**SAN ANTONIO WATER SYSTEM
W6: Western Watershed Sewer Relief Line – Project I
SAWS Job No. 12-2516
Solicitation No. B-12-039-DD**

**ADDENDUM NO. 1
September 19, 2012**

SAWS PROJECT #12-2516
FILE NAME: C-PLPP101
SHEET No
C-6

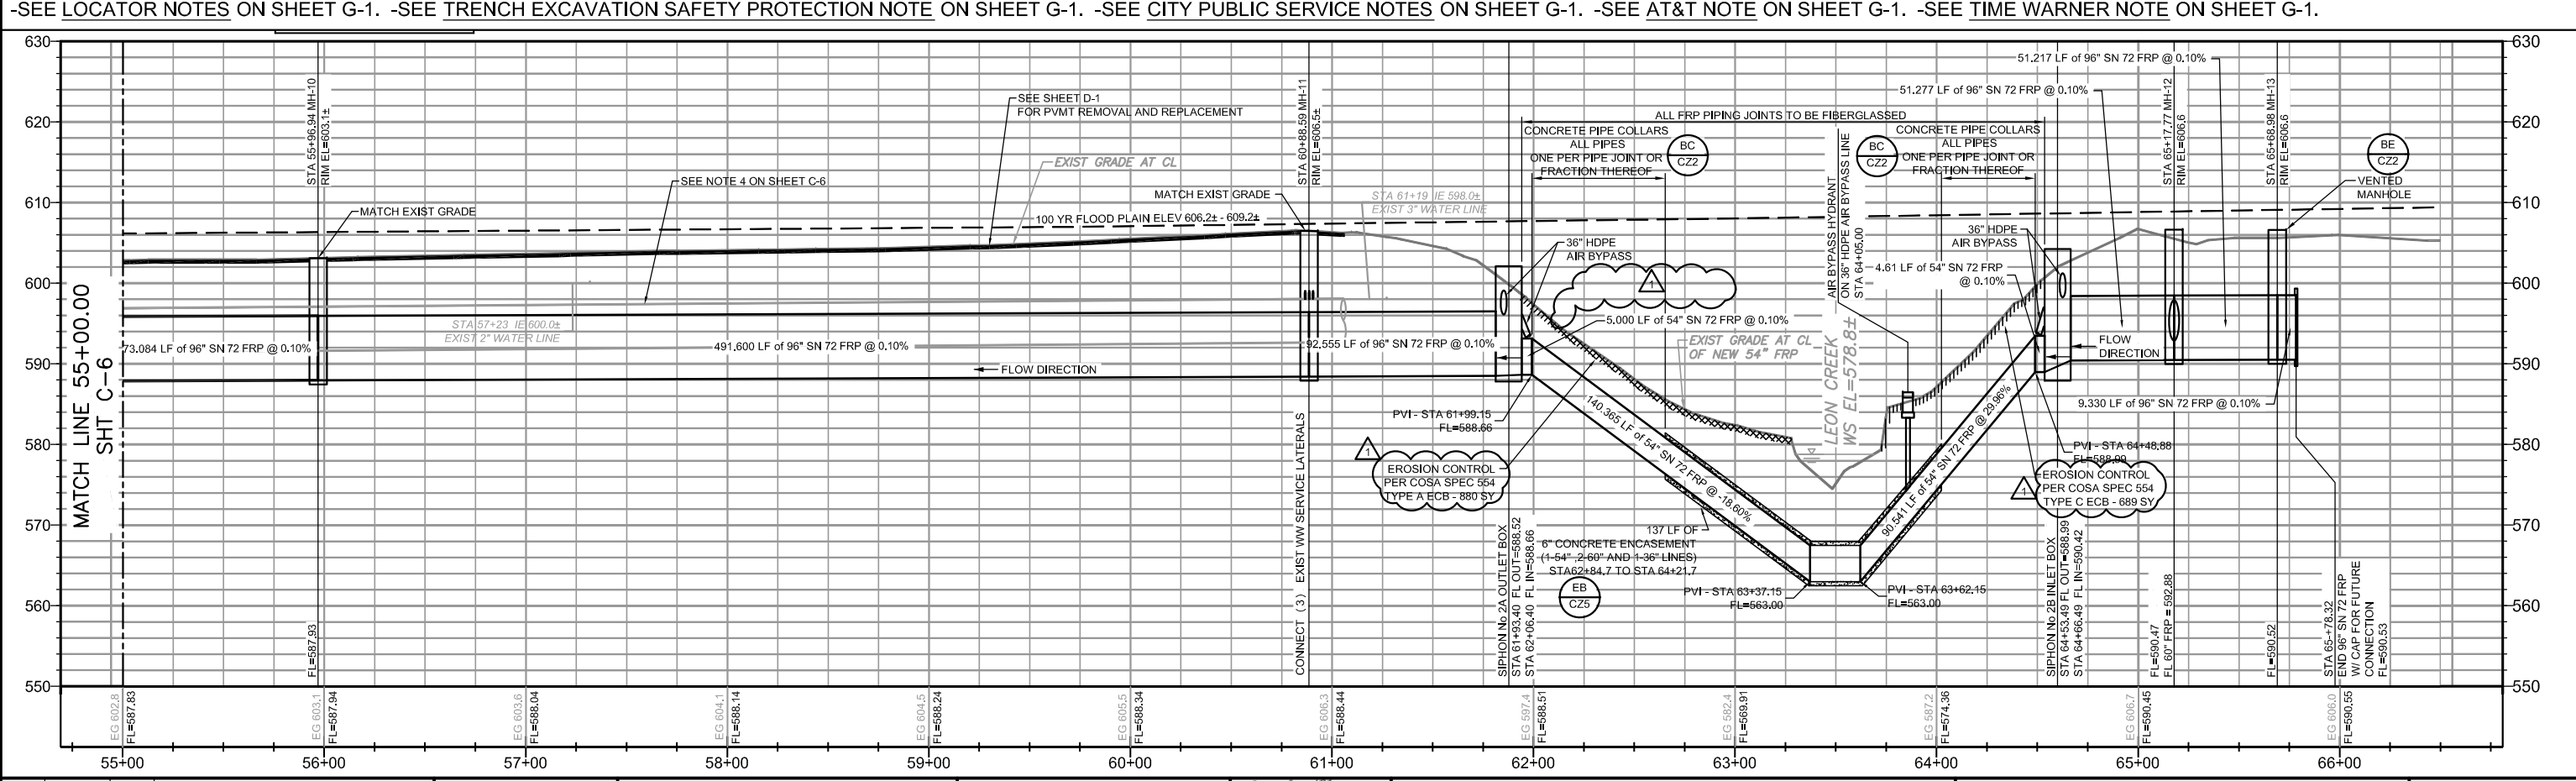
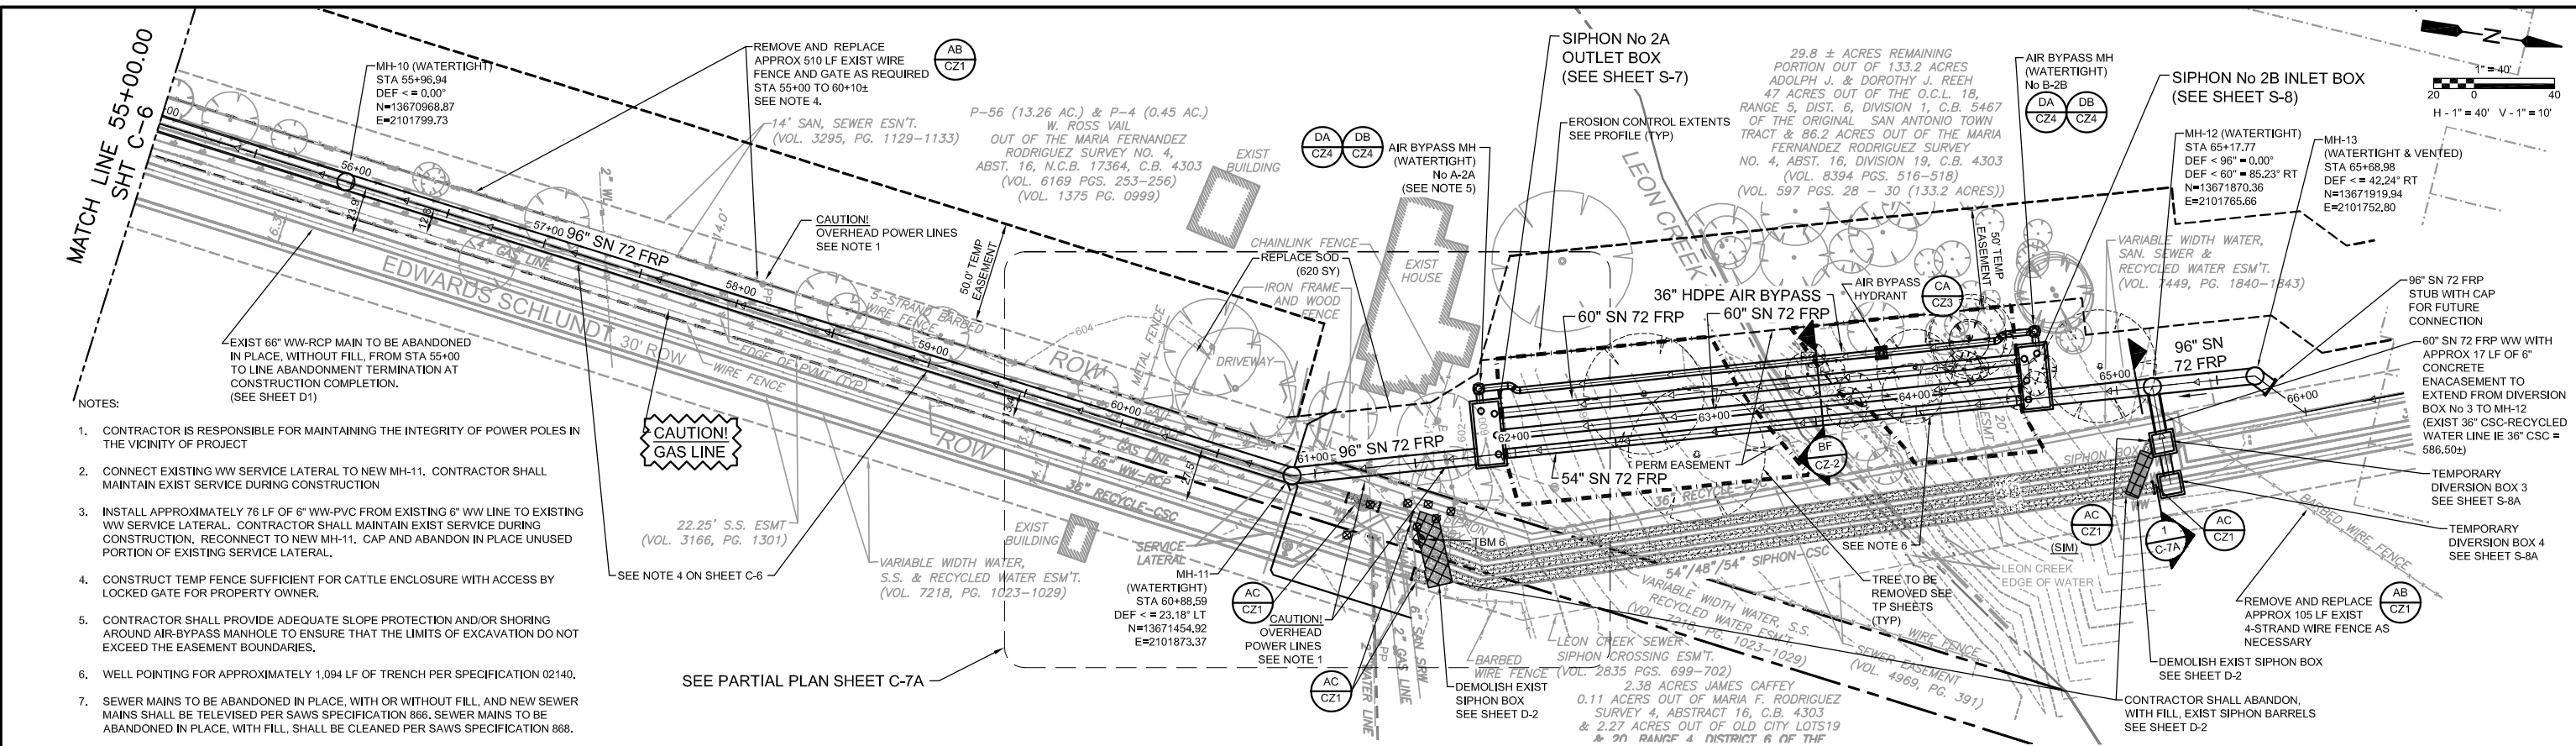
4. Question: Sheet C-6 calls out for 321.2lf of 60" SN 72 Jack and Bore pipe thru the IH 35 ROW. It is typical that all flexible pipes (FRP) are encased inside a steel casing under any TxDOT ROW. Please see attached PDF outlining TxDOT requirements: "Casing shall consist of a pipe or other separate structure around and outside the carrier line". Will a steel casing be required as the carrier pipe for the FRP which is typical of all SAWS projects crossing a major roadway such as IH 35?

Answer: Design constraints do not allow for a steel casing to be installed under IH-35. All jacking pipe under IH-35 shall be of the proper thickness and use the proper couplings to facilitate the site soil conditions.

SHEET No
CZ-5

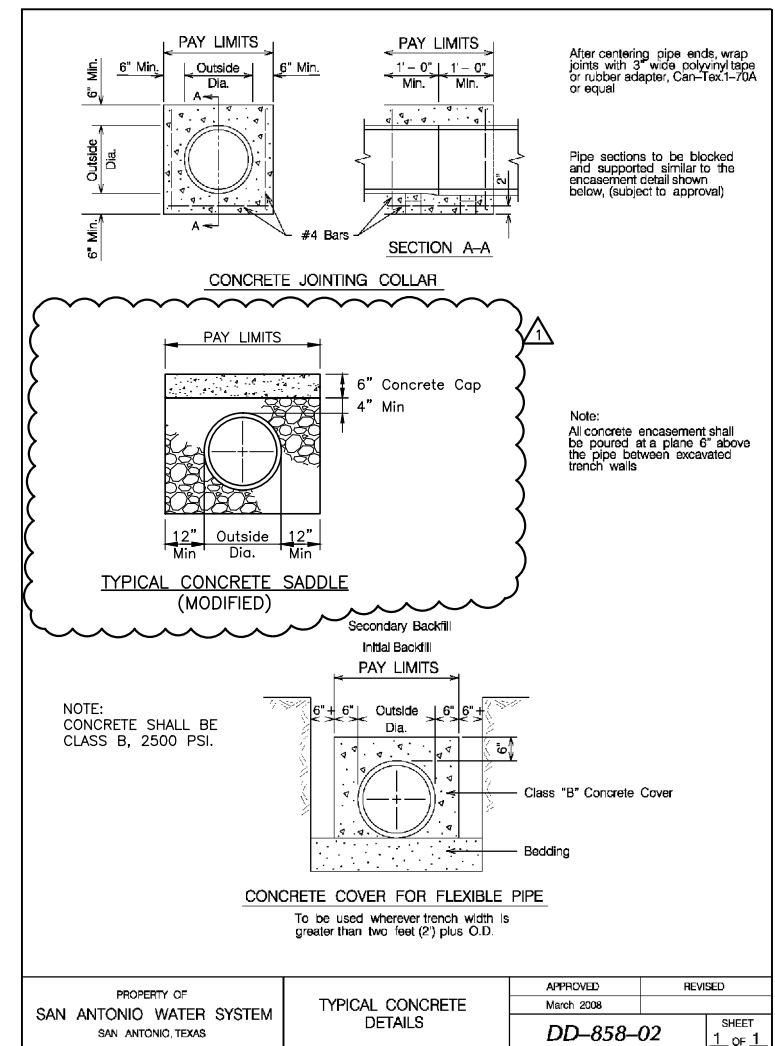
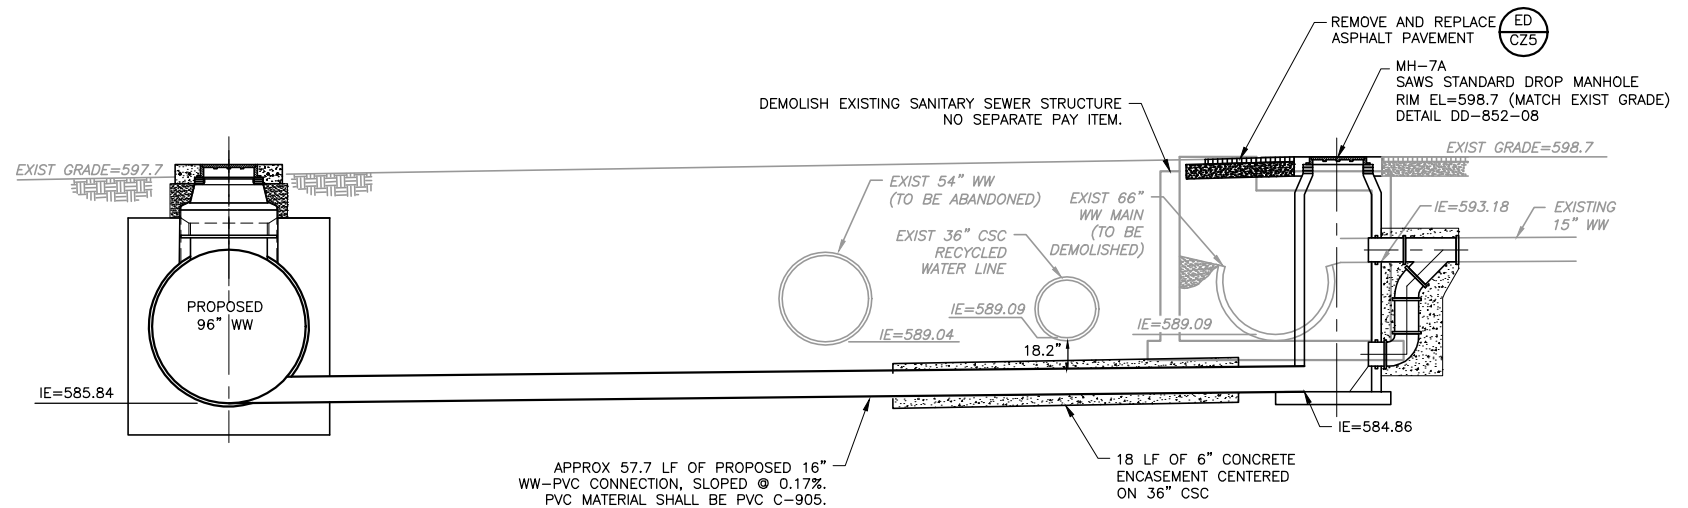
- 6. Question: As noted on the plans for the shallow cover areas, The use of concrete saddles are not recommended, because they (by design) create two different support conditions at the same location on a given pipe. For flexible pipe, a continuous & uniform modulus material for support (surround) is important to avoid stress concentrations and can eventually cause damage. For shallow cover areas, a concrete slab not in contact with the pipe that has a 4" to 6" stone or sand buffer can be used, or complete surround of the pipe can be done.

Answer: The detail on sheet CZ-5 will be modified to show 4" of sand buffer to be installed between pipe saddle and FRP pipe.

SAWS PROJECT # 12-2516
 FILE NAME:
 180031_TREE_PRESERVATION PHASE 1
 SHEET No
TP-3

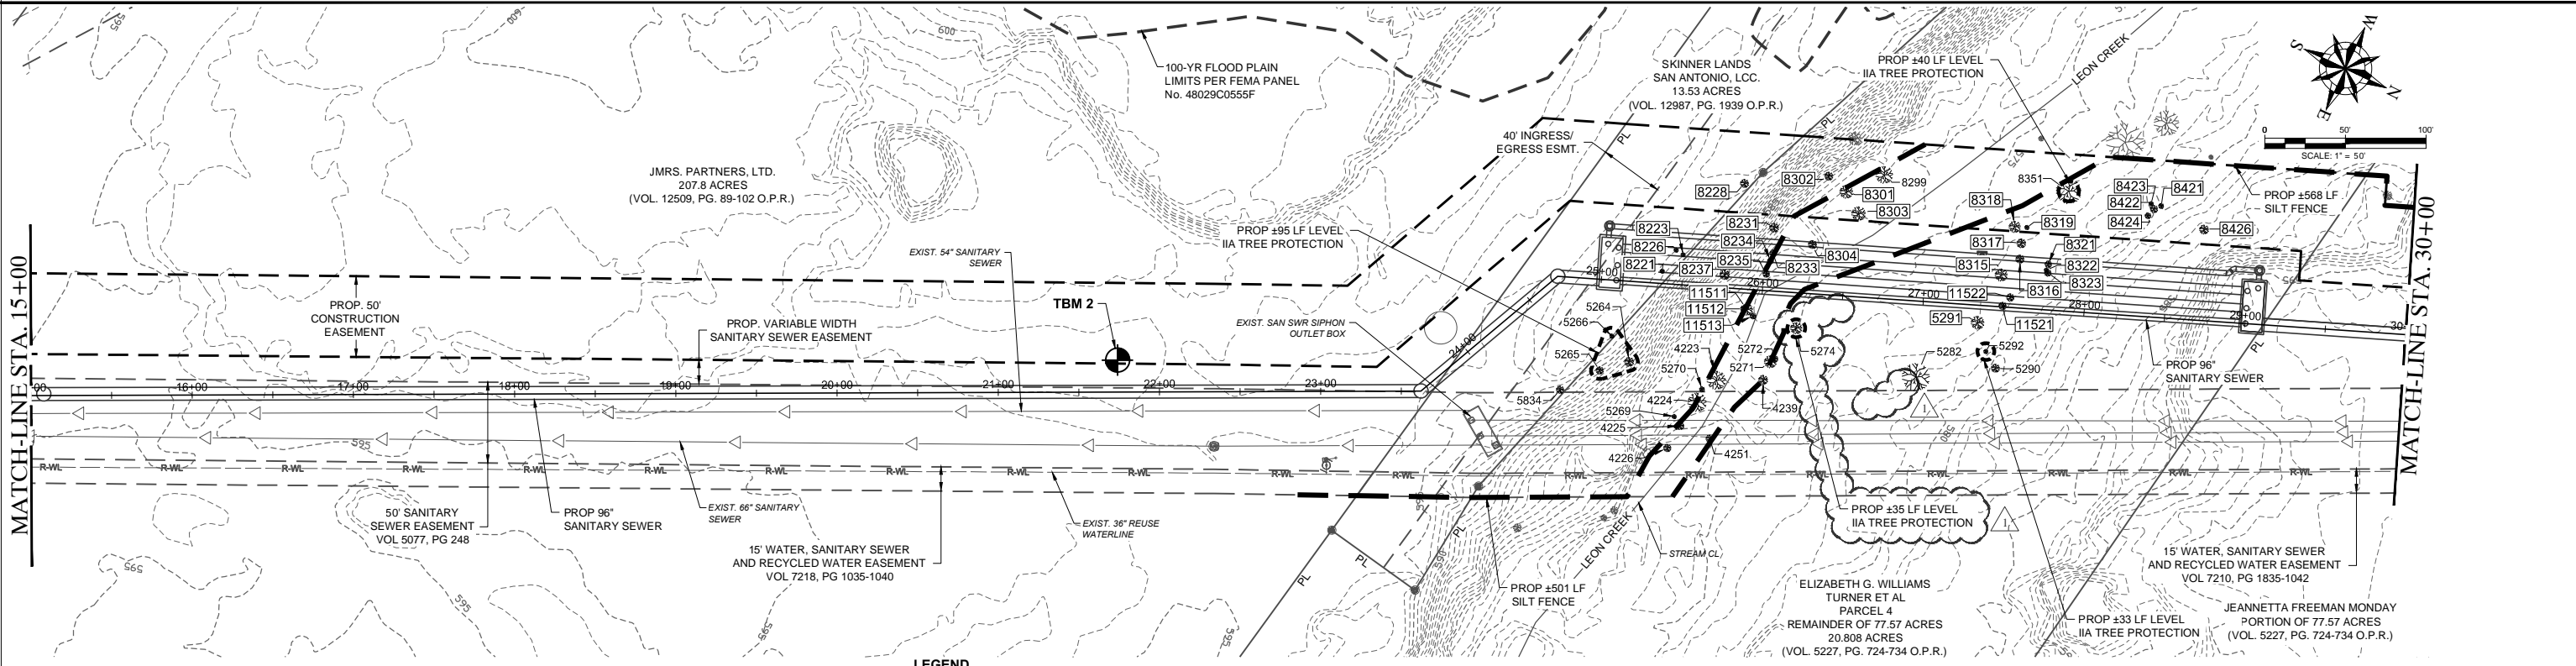
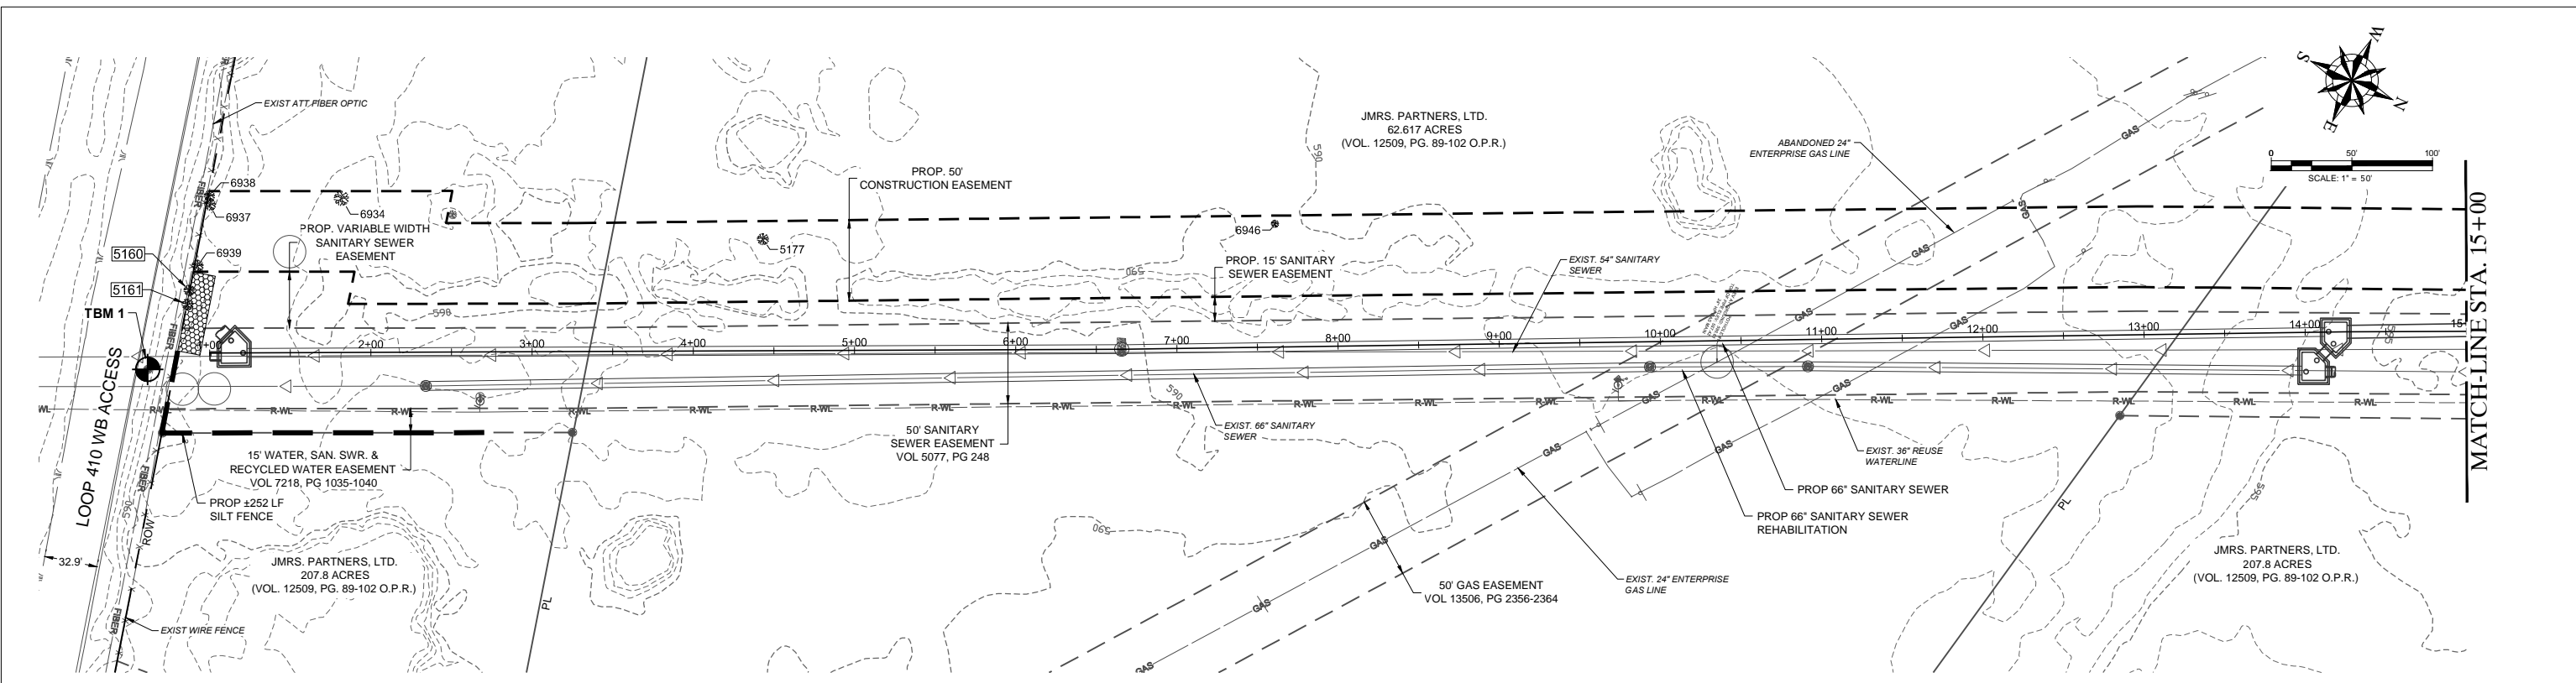
16. **CONSTRUCTION PLANS | SHEET TP-3:** Remove in its entirety and replace with the revised “Sheet TP-3 – Stormwater Pollution Prevention & Tree Preservation Plan: STA 1+00 to 30+00” attached. Revision clouds which appear but have no contents represent trees that have been deleted from the plan per tree inspector comments. The cloud is shown simply to indicate the location of the old tree symbol.
